January 14, 1988
MP-11374

Reference: Facility Operating License No. DPR-65
Docket No. 50-336
January 11, 1988 NRC License Examination Comments

Attached is the compilation of comments on the written examinations administered to Millstone Unit No. 2 license candidates on January 11, 1988.

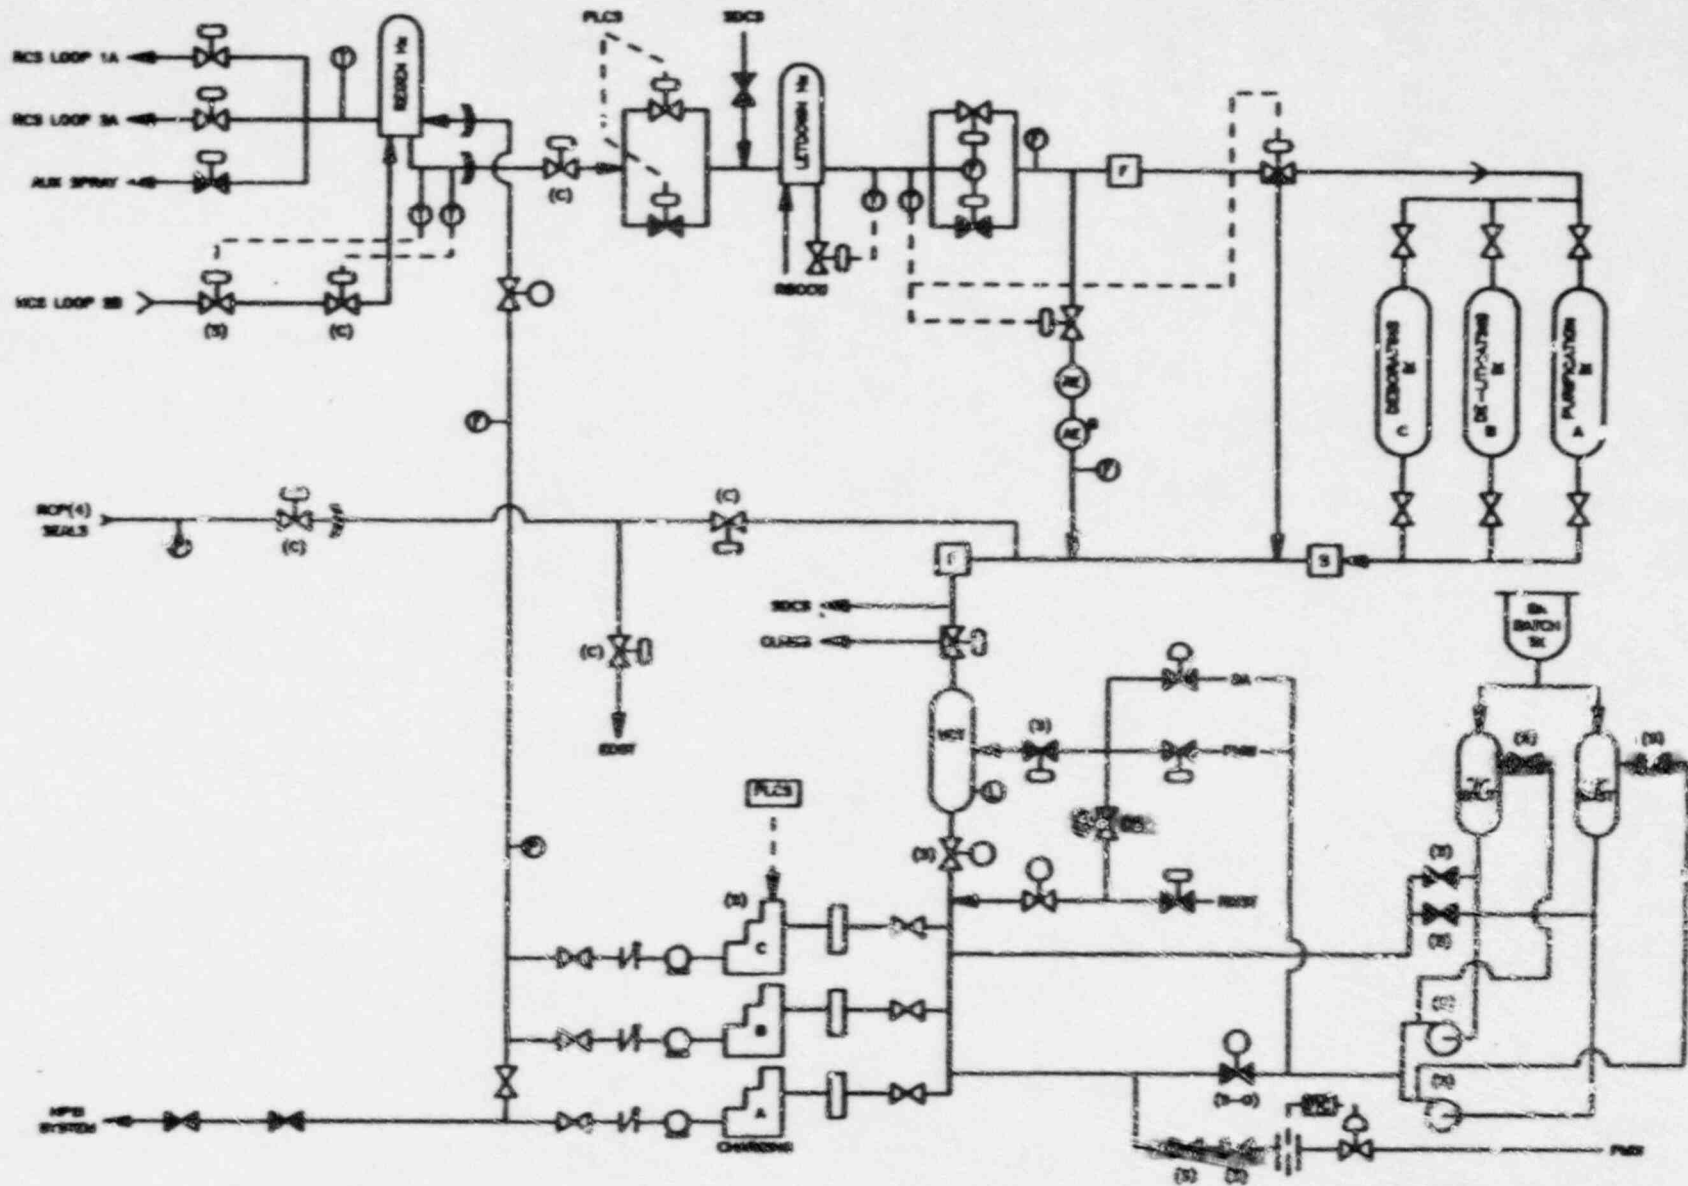
The AFW Flow Control Valves have three modes of operation as stated in both OP 2322 (ref. book 4) and AOP 2579B (ref. book 7). These modes are Auto, Manual and Manual (Local). If an Automatic Feedwater Actuation Signal (AFAS) is present then the "Reset-Normal-Override Switch" has three modes of selection which allow the operator additional modes of operation (AFW SD & OP 2322). As the question did not mention the switch by any name, nor indicate that an AFAS had occurred, it is impossible for an examinee to determine which "modes of operation" the question is attempting to solicit. Therefore, discussion in either area of AFW Valve control should be accepted for full credit.

FIG 8.3-2, SH. A

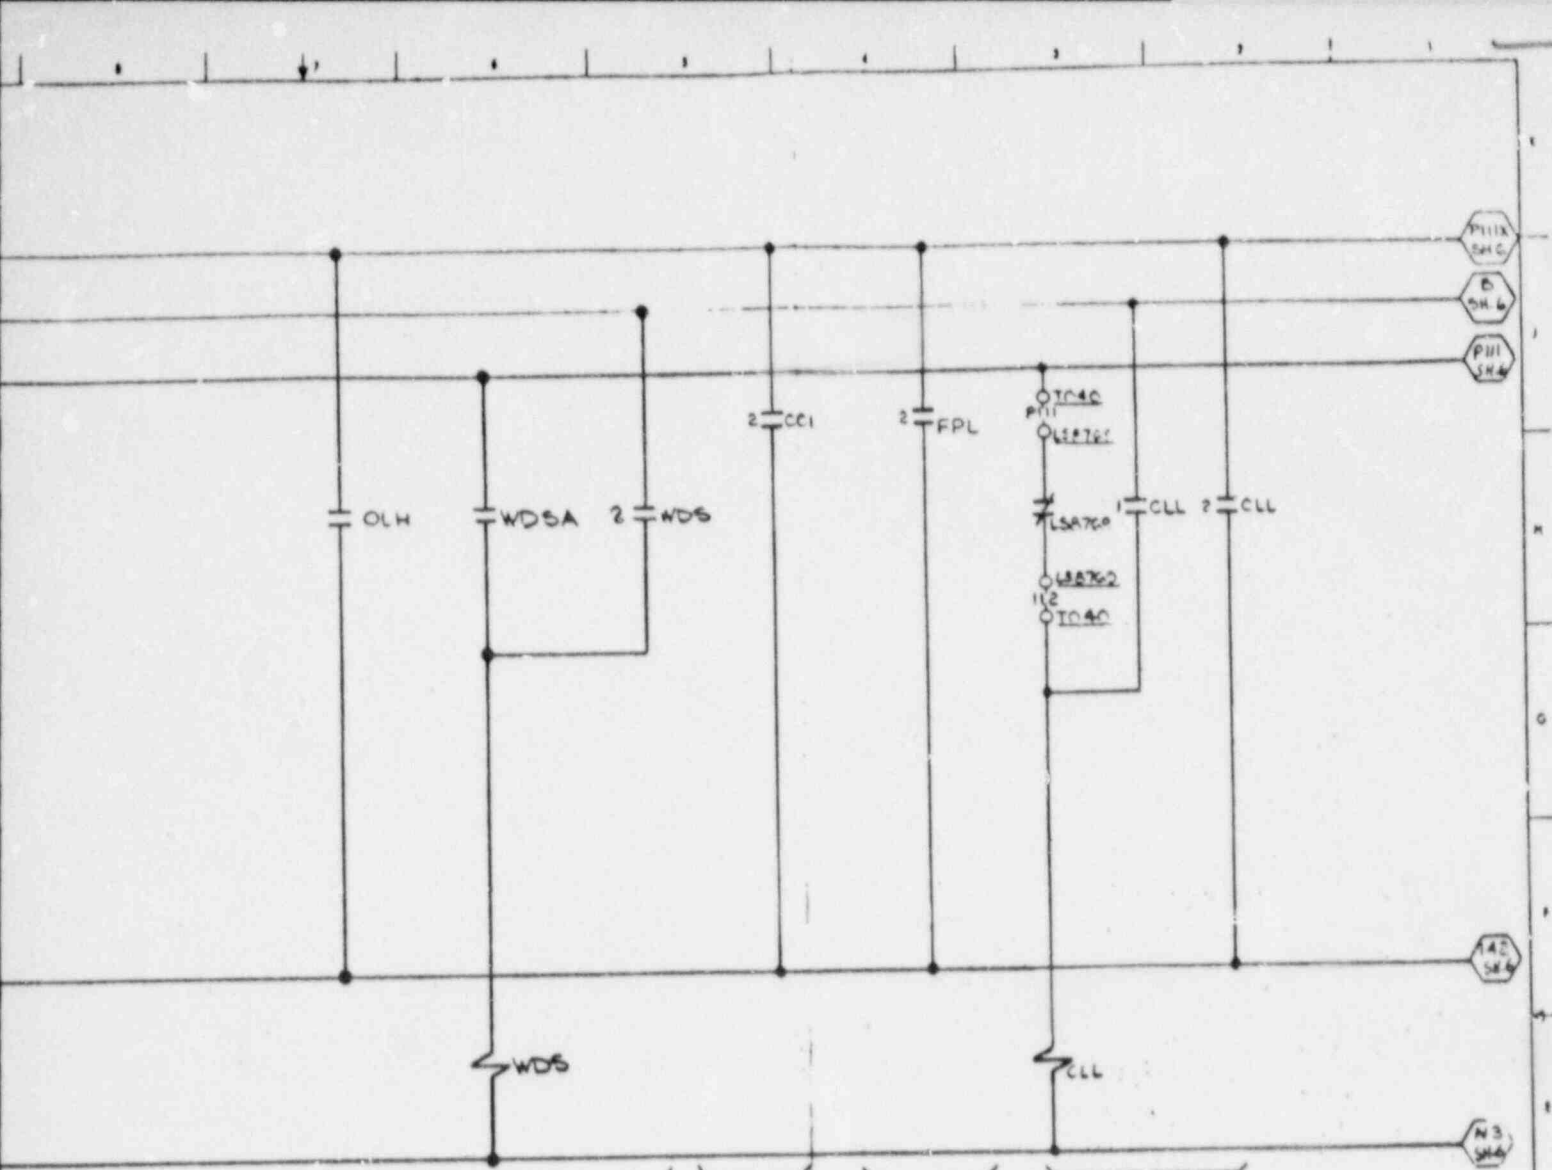
1. Figure 8.3-2 Sheet 12 shows that the "Loss of Control DC," Annunciator is caused by one of four relays: CR1, CR2, CR3, and CF4.
2. Identifying each one of these relays we find that:
 - a. CR1 is the relay that indicates a loss of power to the starting portion of the D/G Control Circuitry. Refer to Figure 8.3-2 Sheet 3.

- d. CF4 is the relay that indicates a loss of power to the Exciter Control Circuitry. Refer to Figure 8.3-2 Sheet 10.
3. A loss of power to CR1, CR2 or CF4 will produce a D/G Trip signal. Refer to Figure 8.3-2 Sheet 6. Note that a loss of power to CR3 will not produce a DG trip signal since the trip circuitry must be de-energized for this relay to lose power. A loss of CR3 will produce a "Loss of DC Control Power" annunciator, however, as shown on Figure 8.3-2 Sheet 12.

FIGURE 22

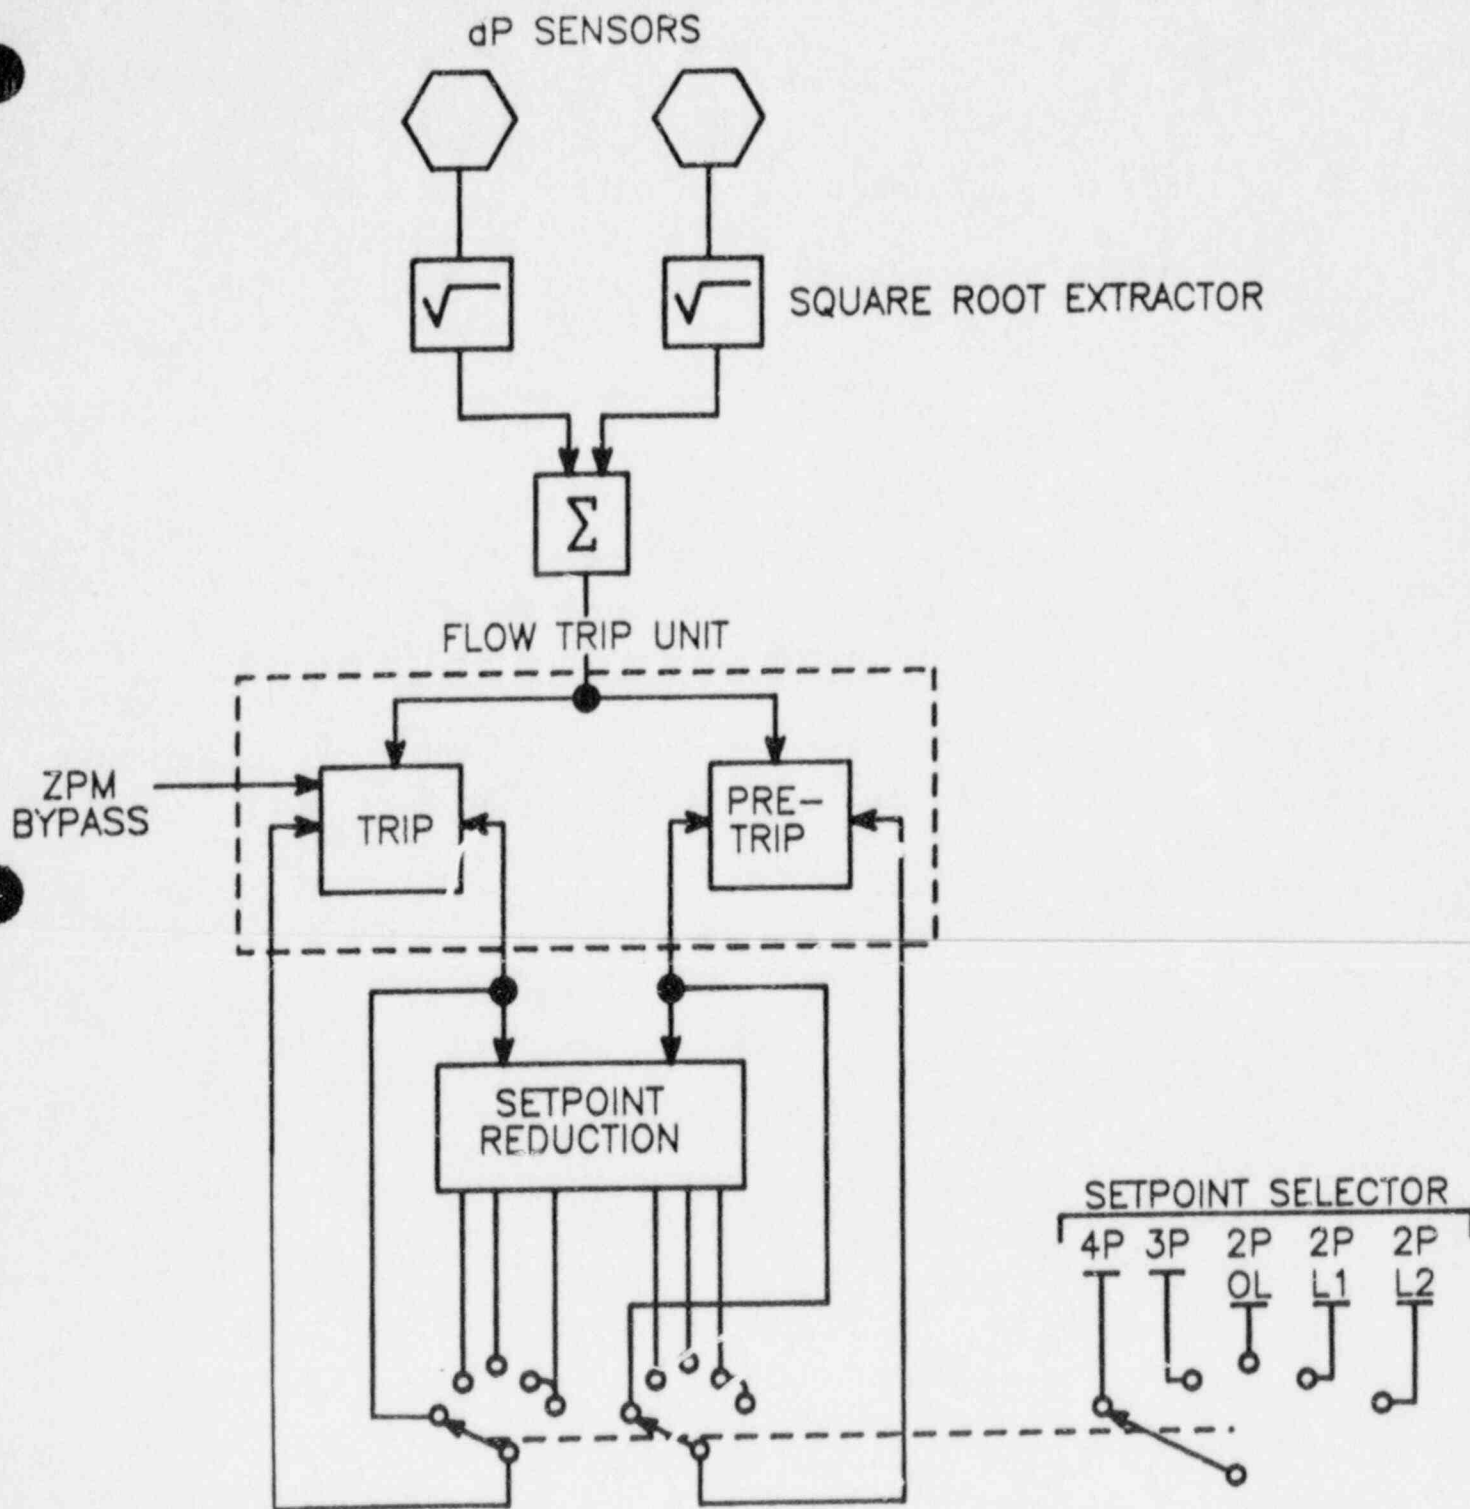
In this part of the question on ECP vs. Actual CEA position, it is stated that one RCP trips two minutes prior to criticality. If this did happen, a Reactor Trip due to RCS Low Flow would occur making the pull to criticality impossible. (Reference attached).
